Aluminum Flatbeds & Combination Drop Decks
Intermodal Container Chassis

RE: Safety Recall Notification # 08V-604

Reinke Manufacturing Company, Inc. has decided that a defect which relates to motor vehicle safety exists in Reinke Intermodal Tank Chassis frames manufactured between December 11, 2003, and March 19, 2004. On certain chassis frames, the lower flange(s) of the frame can develop a small fatigue crack in front of or behind the front suspension hanger. These small cracks can in some cases further develop whereby in certain applications the lower flange(s) may fail, increasing the risk of a crash without prior warning.

REINKE MANUFACTURING CO. INC. 2525 1/2 RD. HERRICK, OH 44040 OFFICE: TEL. 440.265.8200 FAX: 440.265.8201 WWW.REINKE.COM	REINKE	
	DR. BY: HEJ MTD. BY: HEJ Sheet 2 of 2	
Title: FR. LWT. 9" - SPND. REPAIR		
Date: 11/13/200		Revision:
Part No.: 33236ENG		-

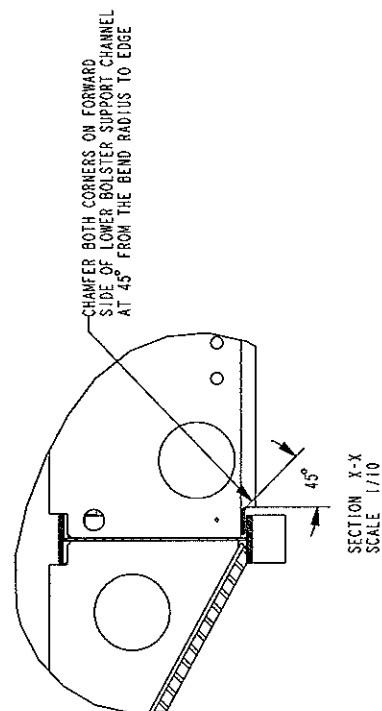
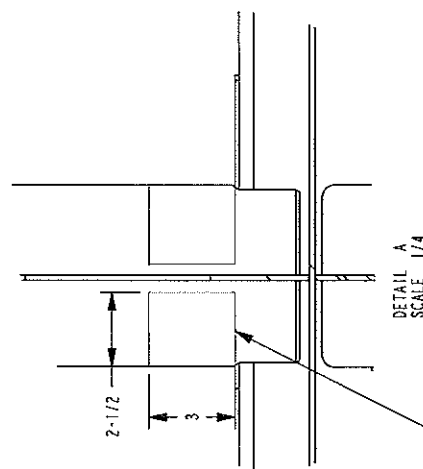
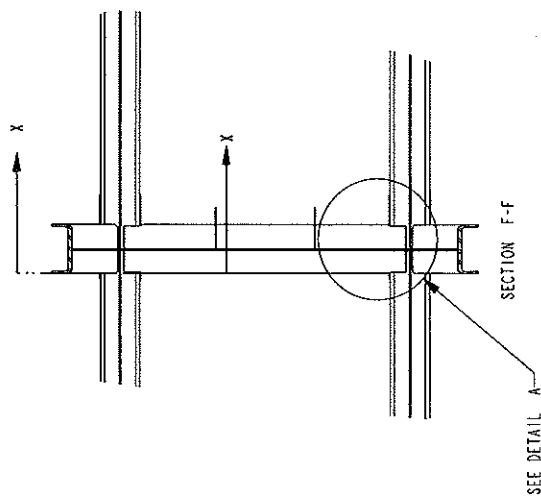
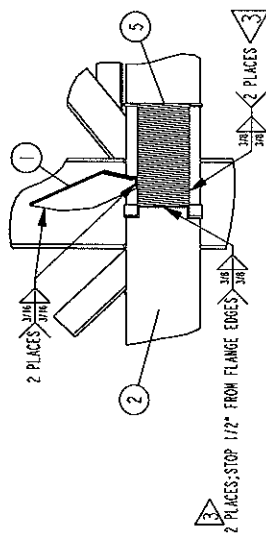
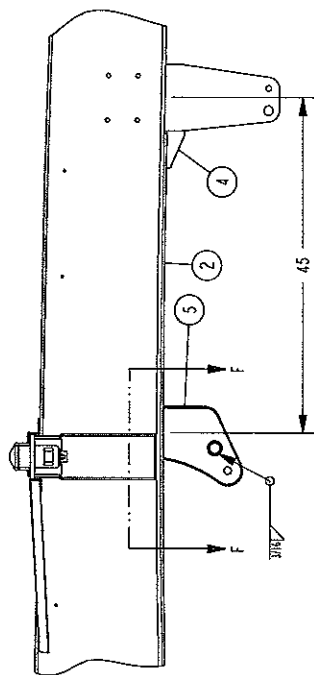
REMOVE A 3" X 2-1/2" PIECE (4 PLACES) FROM THE LOWER CENTER TWIST LOCK SUPPORT, ABOVE THE FRONT HANGERS, TO ALLOW FOR THE 15" WELDS ABOVE THE FRONT HANGERS. REPLACE CUTOFF PIECES AND WELD INTO PLACE AFTER 15" WELDS ARE MADE.
